RECEIPT DATE: 11-19-25 **ONSITE SEWAGE DISPOSAL SYSTEM** P 590281

APPROVAL DATE: 1/15/26 **PERMIT: NEW CONSTRUCTION** A _____

PROPERTY ADDRESS: 857 Morgan Station Road

857 MORGAN STATION ROAD
 WOODBINE, MD 21797
 LOT 2, PLAT 18989, MAP 8
 GRID 2, 48,494SF, ACCT#04-593623
 ONSITE SEWAGE DISPOSAL
 SYSTEM DESIGN PLAN

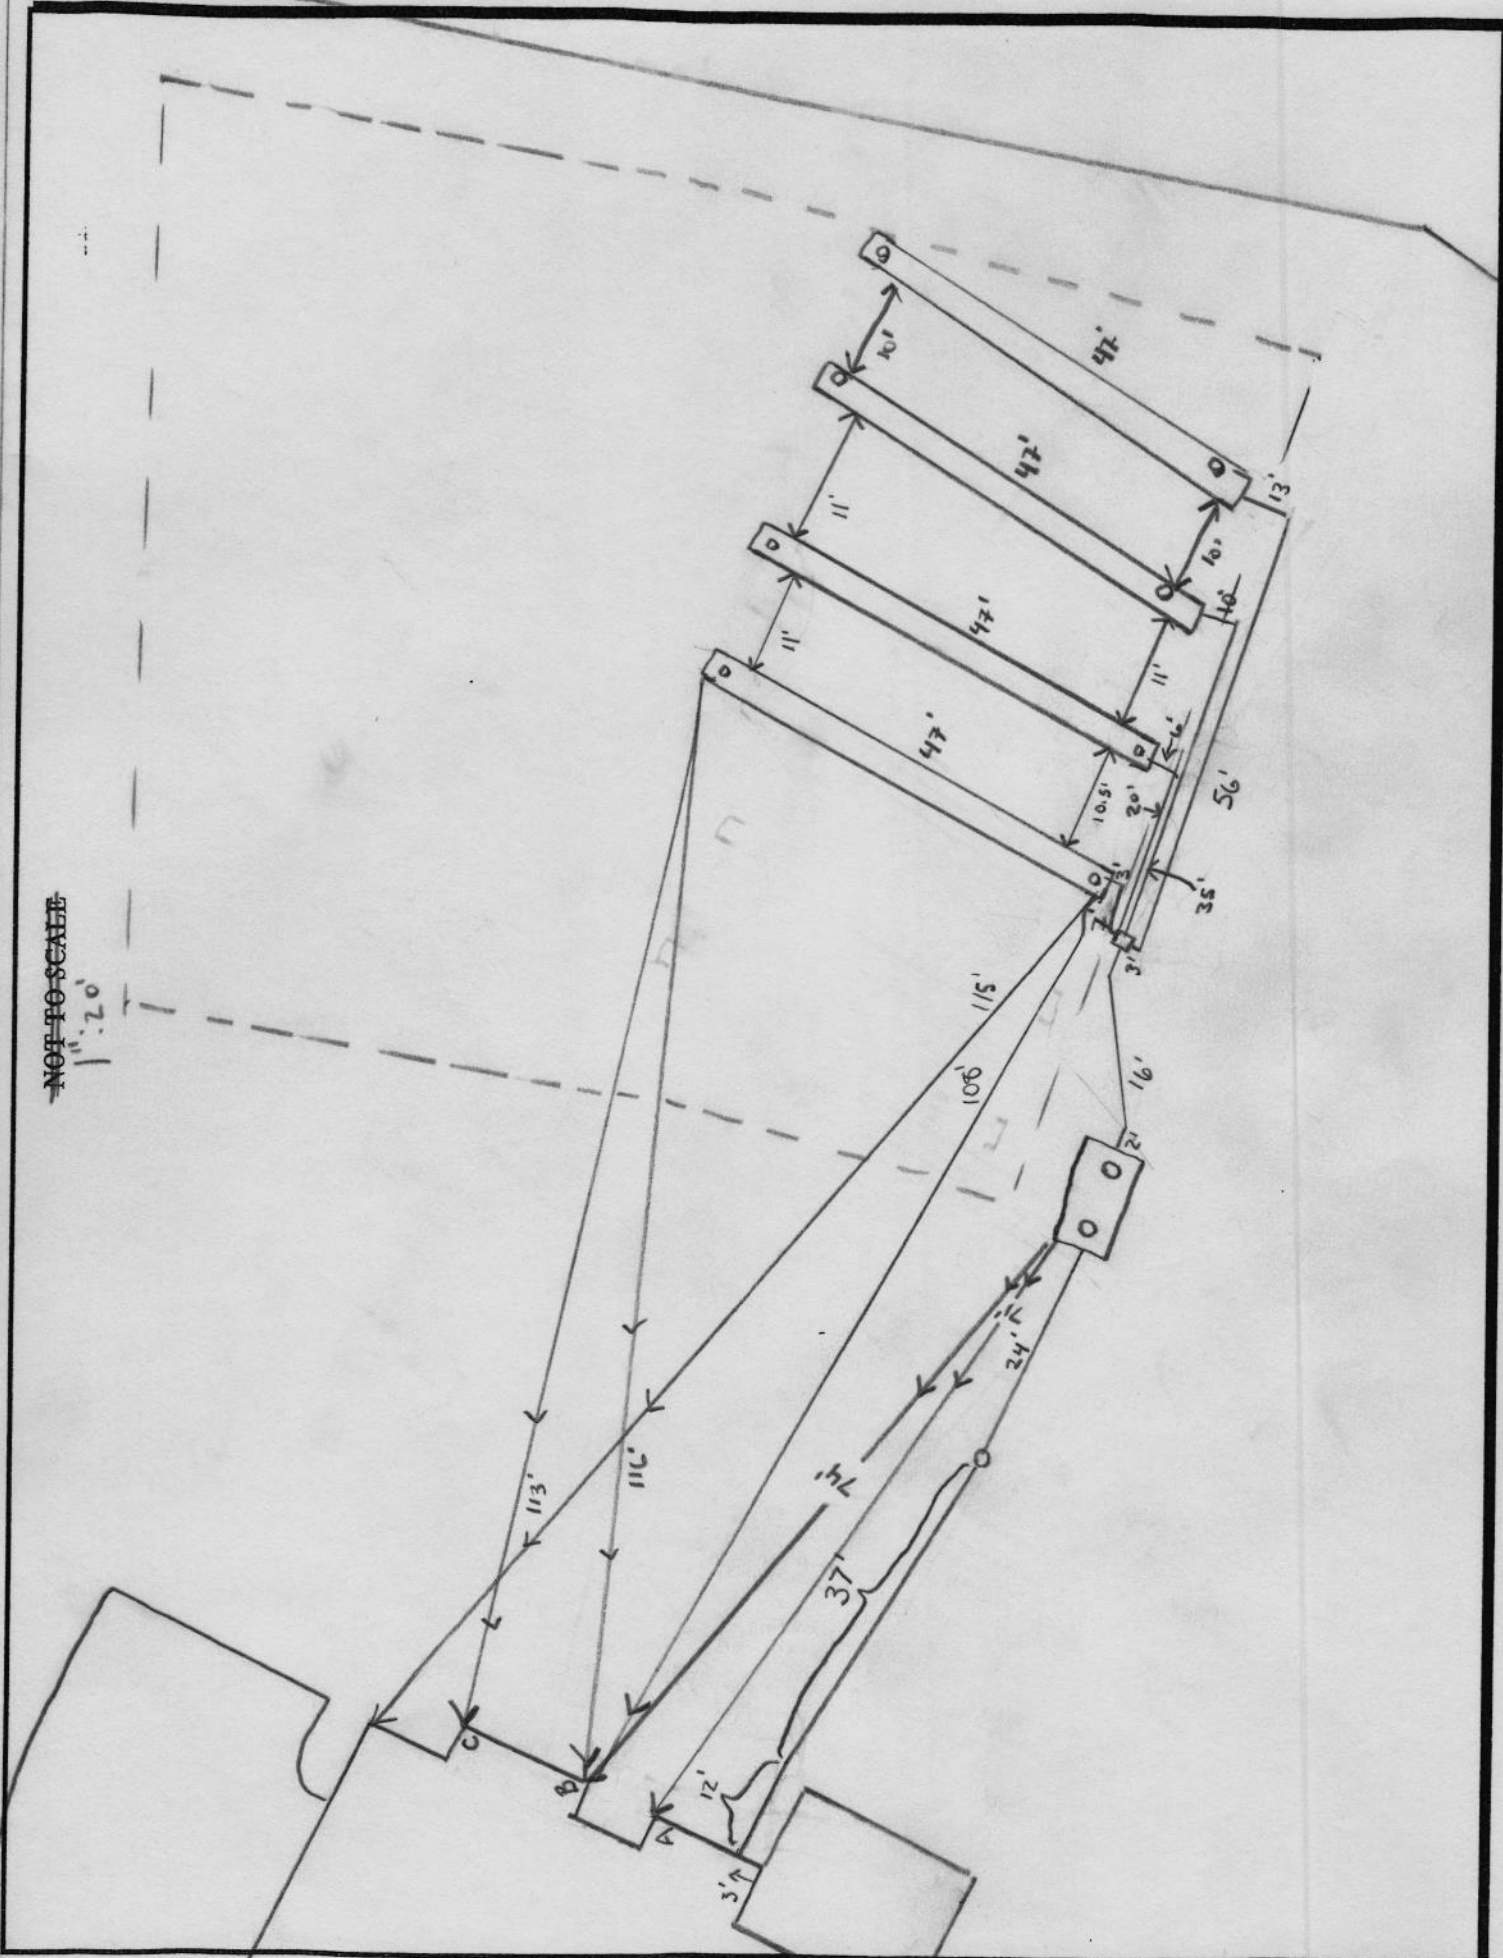
11/24/2025-Installer & Builder onsite for pre-con sewer out of house excavated. Elevation from sewer to proposed tank w/ 1%. Fall would be too deep; \Rightarrow 3' cover on tank & would not make inlet @ trenches. Builder wants to move ST downhill & install PT to trenches. **SP/MB**

1/13/2026-Installer onsite for pre-con. Tank & SDA started for plan trenches 211 @ 47'. Discovered realine changes, installer understands trenches changed to 47' & bottom @ 4', inlet @ 3.5'. Tank to have 43' cover & sewer line holding 1%. Trenches on contour. OK to start work. **MB**

1/15/2026 Trenches 1 and 2 have been dug. 3.5' inlets. Trench lengths per plan with geotextile fabric added. Distance between trenches 1 and 2 are 10.5' - 11'. D-box leveled. OK to backfill. **MB**

11/21/25 Revisited plan's trench, SDA, tank, and d-box started. Trenches are on contour. Contractor having trouble locating stubbed out pipe coming out of footer. Plumber will be locating stubbed out pipe tomorrow. **MB/SP** 11/22/25 spoke with builder superintendent. Pipe has been camera'd and is located further over than what was dug. Contractor to dig 1/4 on Monday to verify pipe depth. **MB**

1/13/2026 - Front line completed. Contractor confirmed 1% fall. Balled pipe with 57 stone for pipe 20' or so. Schedule 40 pipe used. Installed 2 cleanouts. Tank installed and level. Tank has sloped. 1' risers installed, more may be added depending on final grading. Well is \geq 100' from SDA. **MB**

1/14/26 Back line to d-box 15 ft. Stone on site and 15 OK. Trenches are 11' apart. Contractor starting trenches. **MB**

1/14/26 Contractor has trenches 3 and 4 dug. Using a laser level to measure bottom. Trench 4 inlet at 3'-3.5'. Observation ports added on both ends. Geotextile fabric added. Distance between trench 4 and 3 is 10'. Asked contractor to have distance at 11' for next two trenches. Trench 3 installed with 3.5' inlet Geotextile fabric installed. OK to backfill trenches. **MB**

ONSITE SEWAGE DISPOSAL DESIGN PLAN

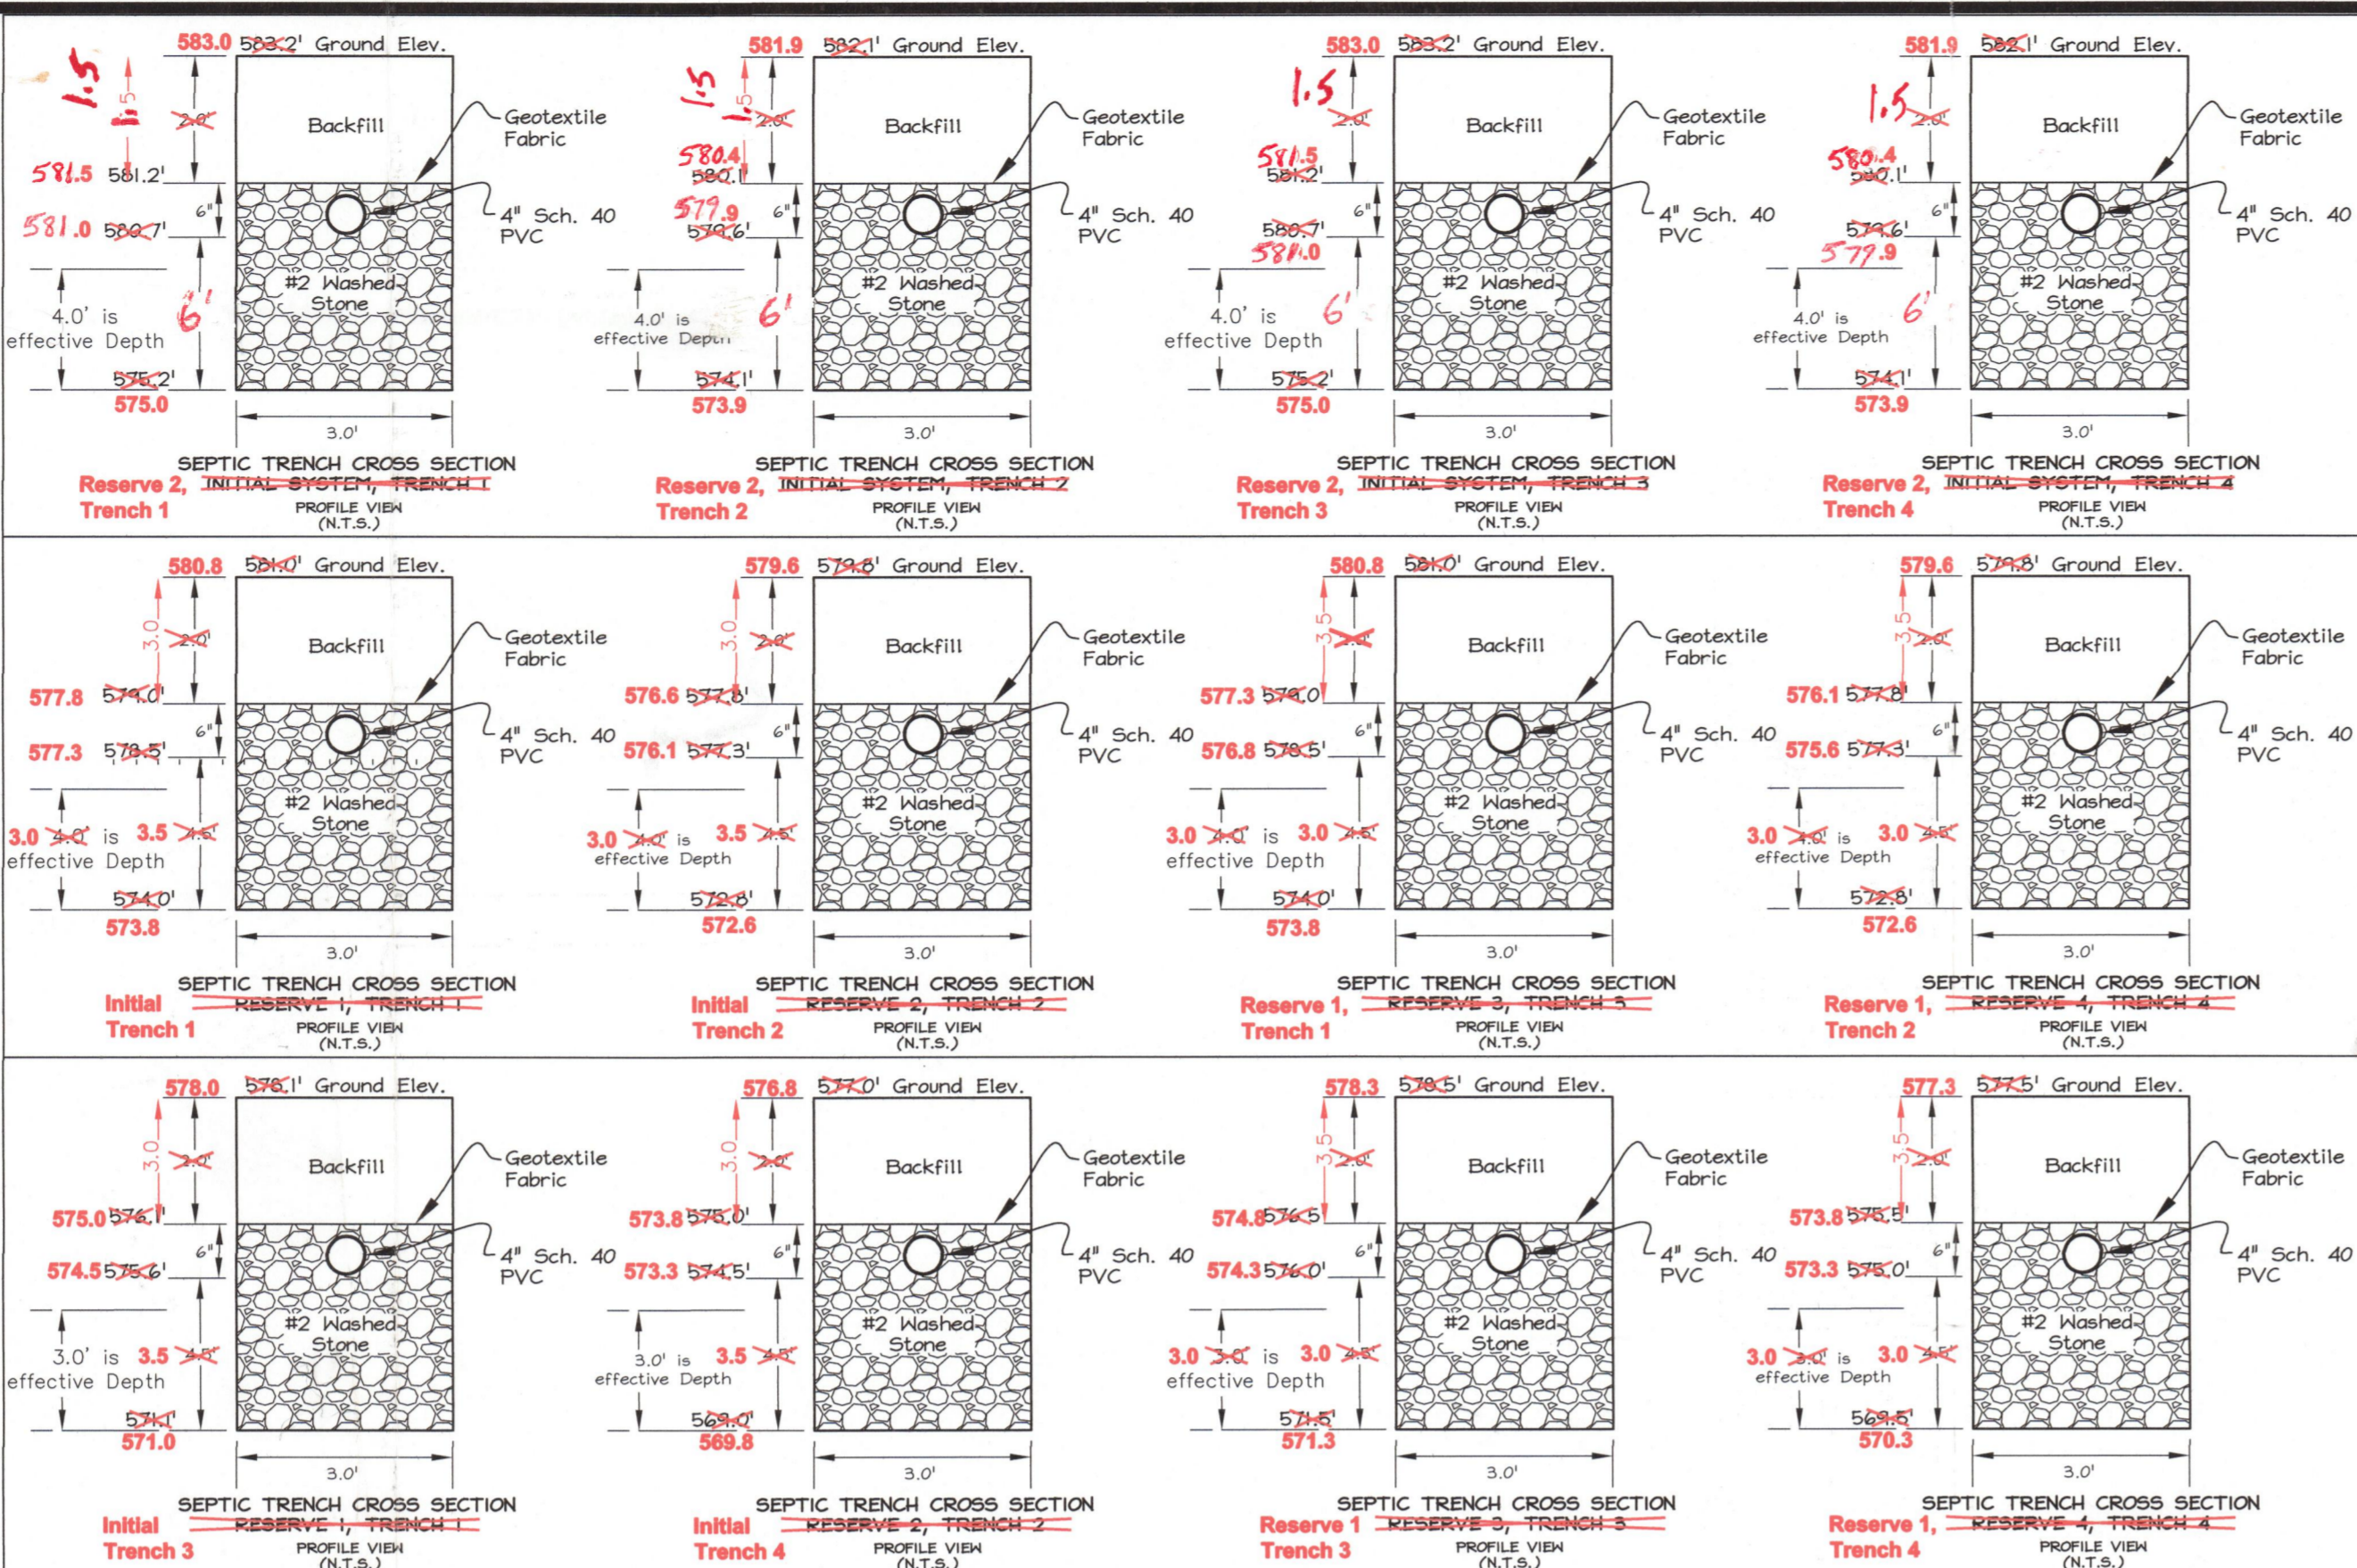
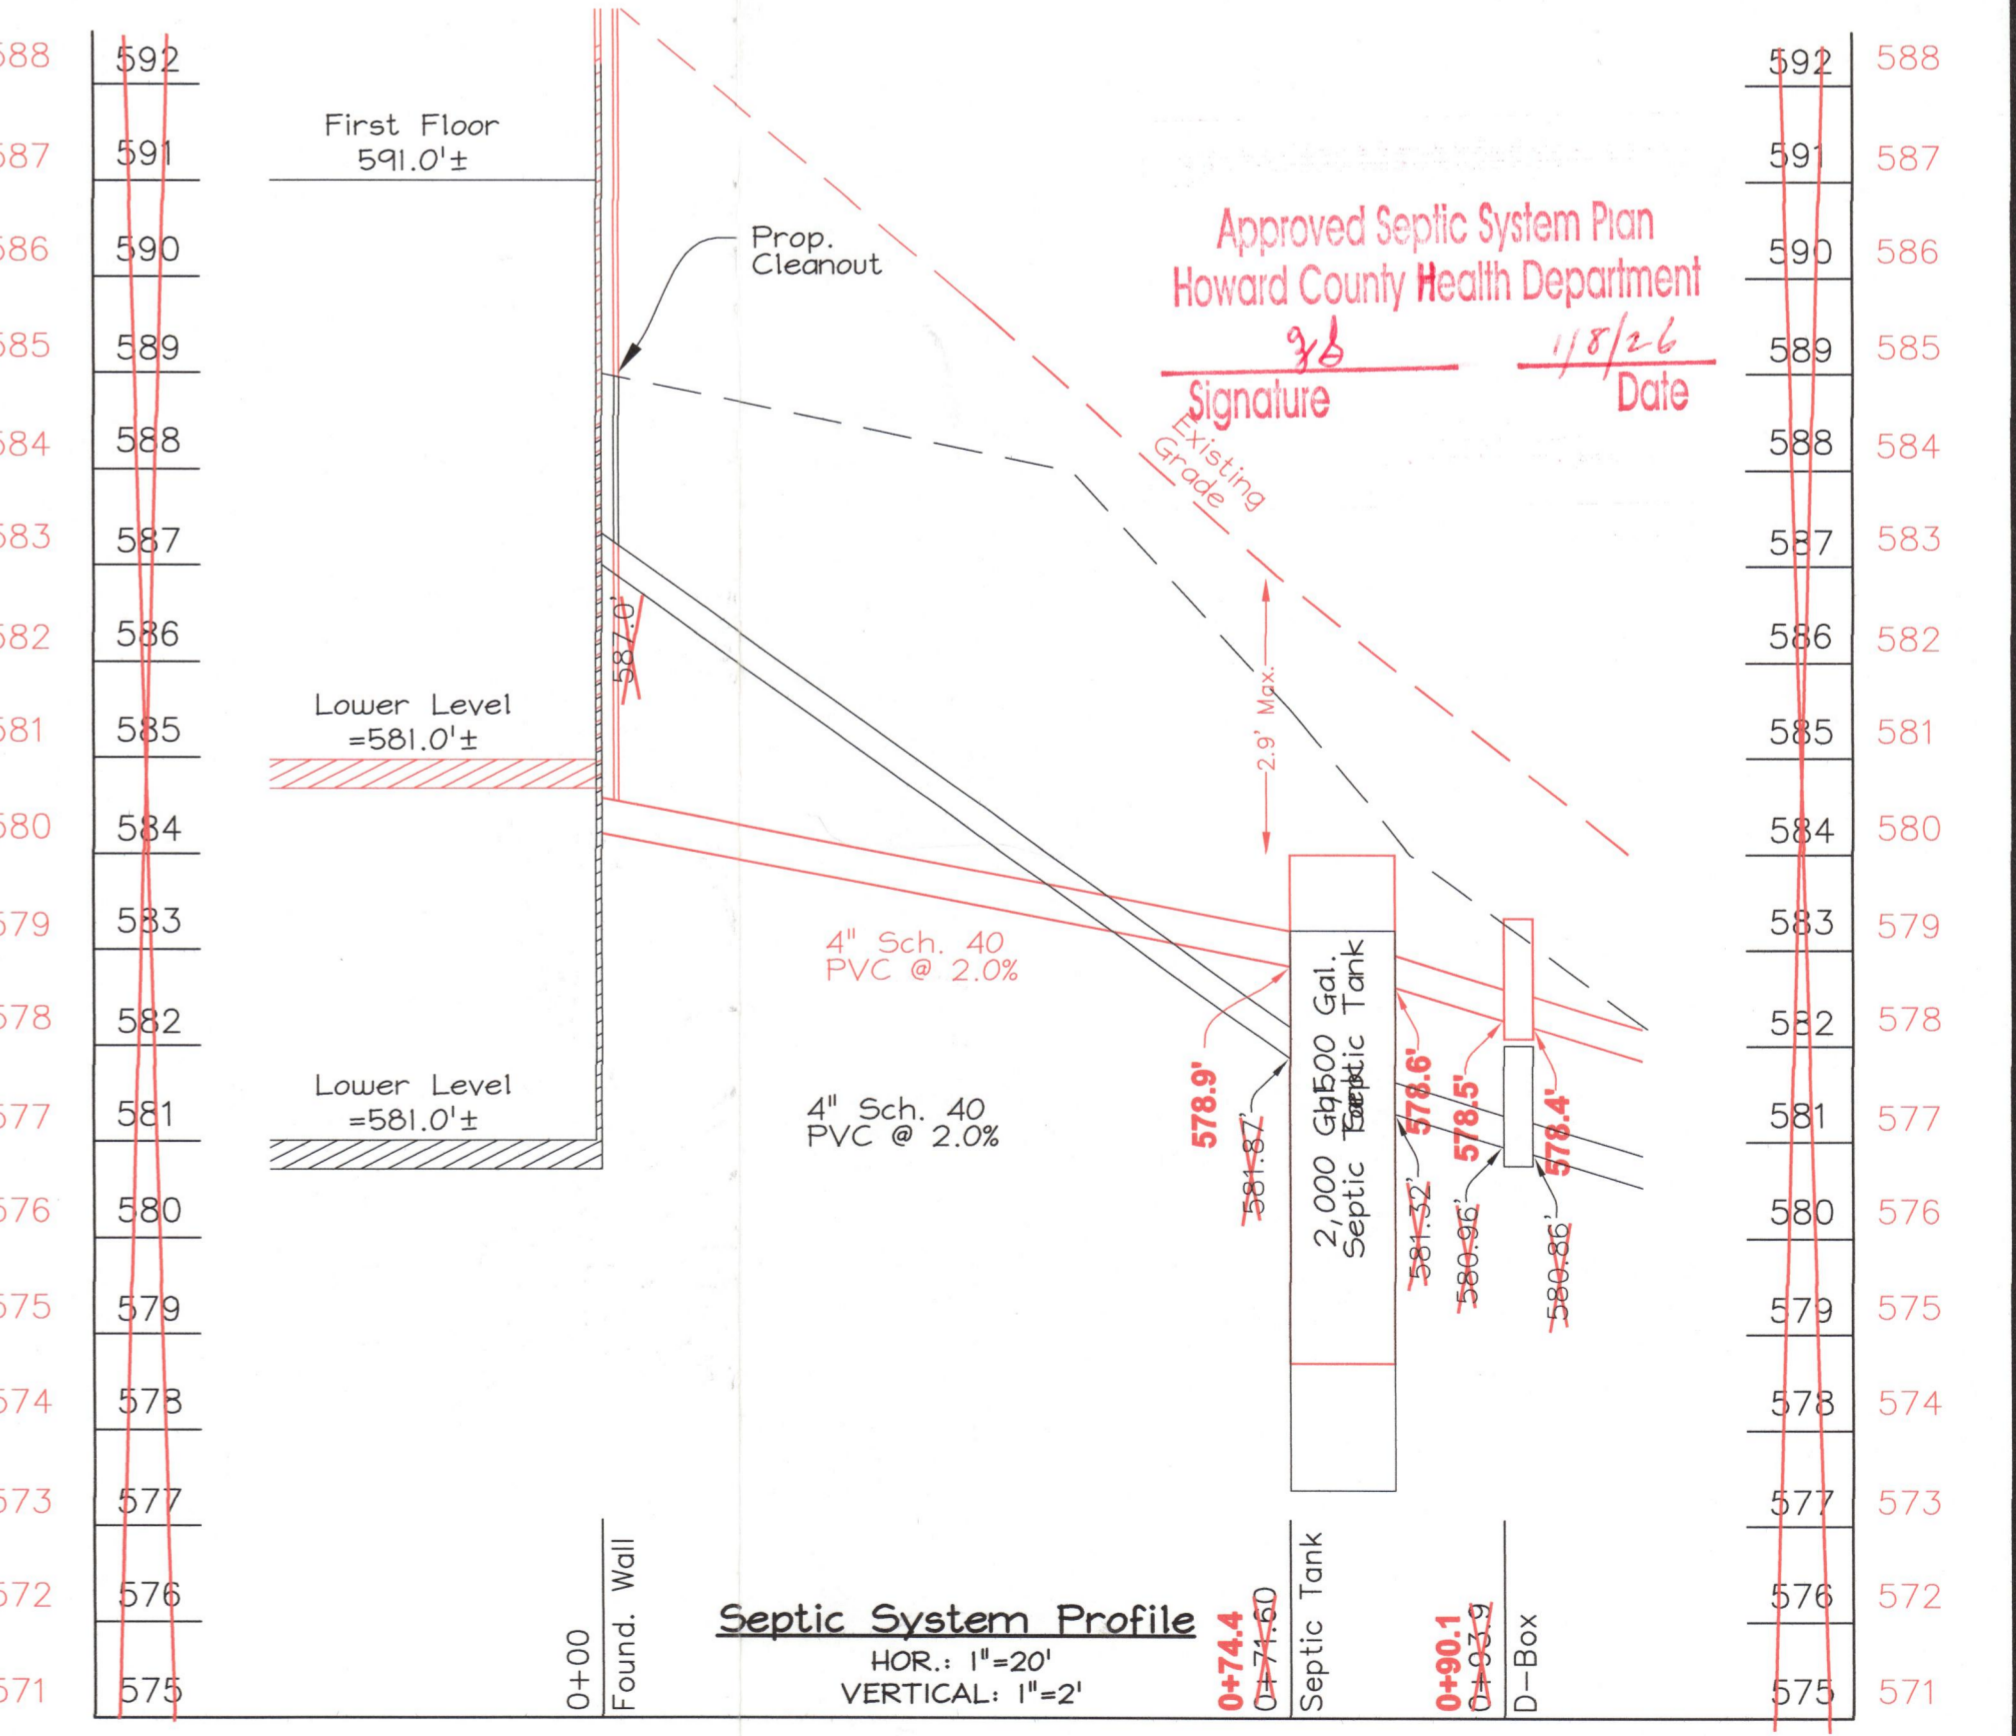
1. **The septic contractor made it seem like the main septic line leaving the house was under the “enclosed porch.” Is your redline piping accurate and we do know that the invert out of the house is 580.4’ and coming out of the house at that location?**
 - a. **Can you provide that confirmed invert depth on the septic profile as well.**
2. **For the initial system, all of the invert depths should be at 3’ for all four of the trench lines.**
3. **For the 2nd reserve system, all of the invert depths should be at 2’.**
4. **ON septic system profile it says 1500 GAL tank, should state 2000 GAL.**
5. **Add a general note that states, “When the 2nd reserve septic system is required to be installed, a pump chamber will be required and an updated OSDS plan with all required details and pump calculations must be provided to the Health Department for approval.”**

This is the plan I just left a message about. They are about 1-foot low at the top trenches. They wanted to use the 1st reserve system now to avoid installing a pump. If/when the first system fails they could go to the second reserve or install a pump at that time. Please let me know if this would work.

- ALL WELLS SHOWN ON THIS PLAN HAVE BEEN FIELD LOCATED AND ARE ACCURATELY SHOWN.
- When the 2nd reserve system is required to be installed, a pump chamber will be required and an updated OSDS plan with all required details and pump calculations must be provided to the Health Department for approval.
